ADDENDUM NO. 1 DATED 11/19/2013 ADDENDUM NO. DATED
 ADDENDUM NO. DATED ADDENDUM NO. DATED

Number	Description
1	Revise Table of Contents, replace same; Add Supplement to SP No. 907-107-14; Revise or Added Plan Sheet Nos. 2, 2002; Amendment EBS Download Required.

HSIP-0009-02(078) / 106418301 Warren County(ies)

SUPPLEMENT TO SPECIAL PROVISION NO. 907-107-14

**MISSISSIPPI DEPARTMENT OF TRANSPORTATION
DETAIL OF TRAFFIC
SIGNAL HEADS, TRAFFIC
SIGNAL SIGNS, AND
GENERAL NOTES**

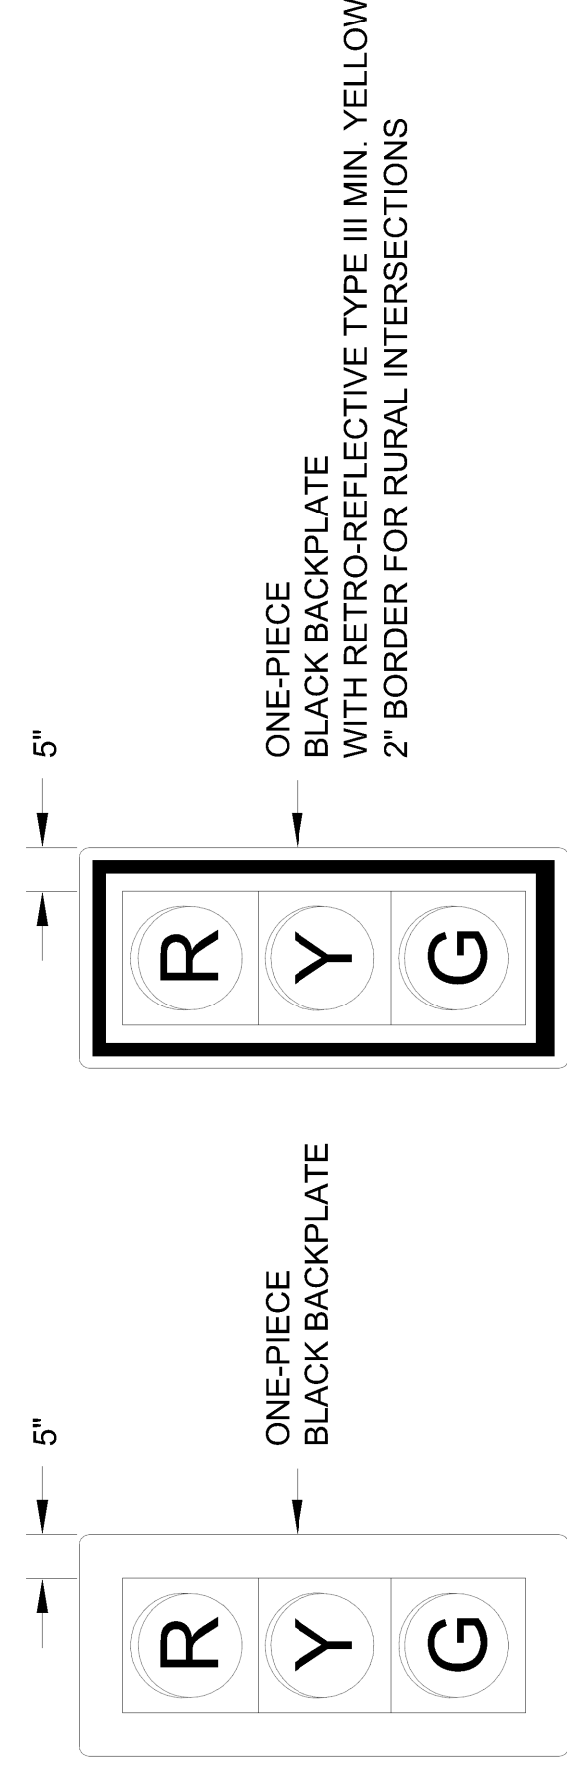
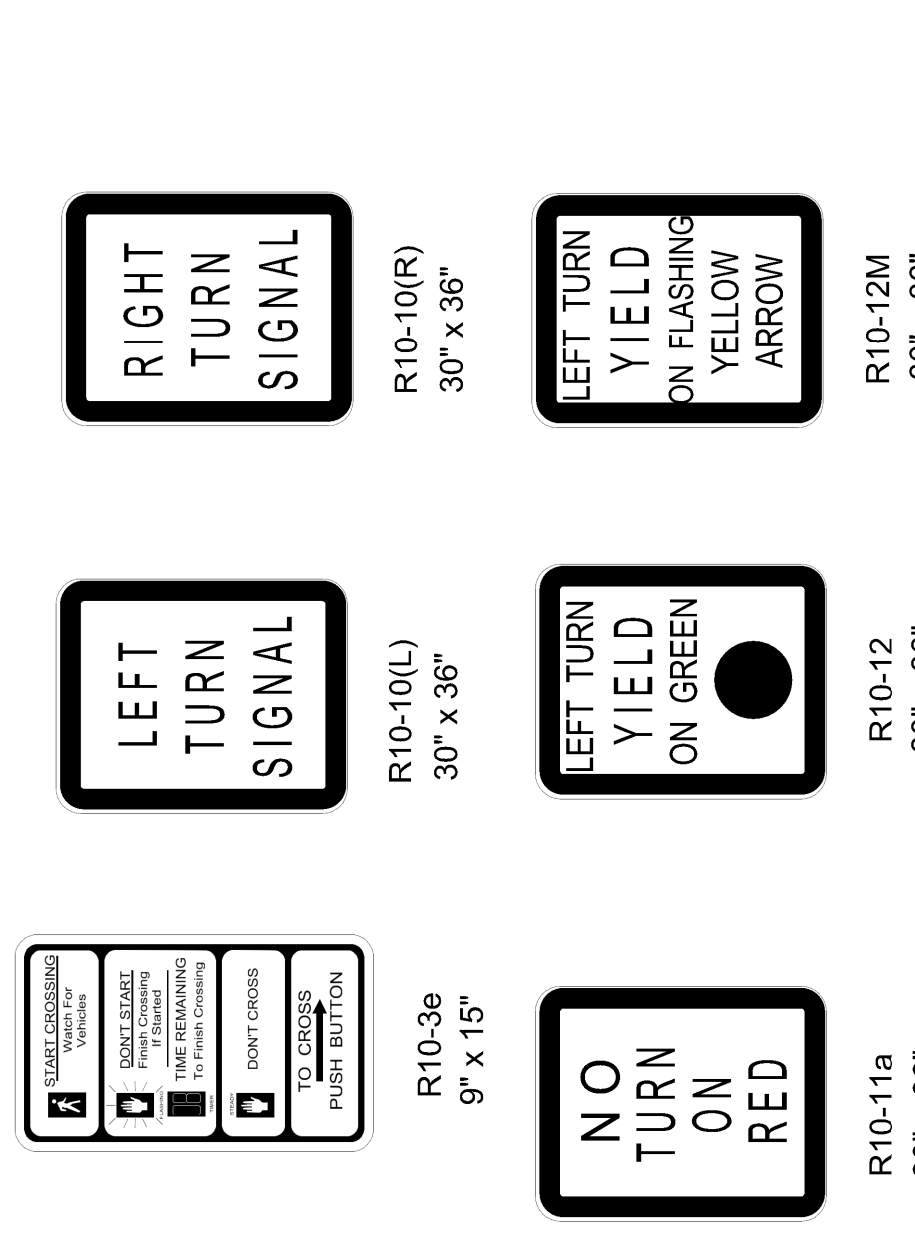
NO.	DATE	BY	REVISION
10/2013			ADDED TYPE 2 FYA SIGNAL HEAD
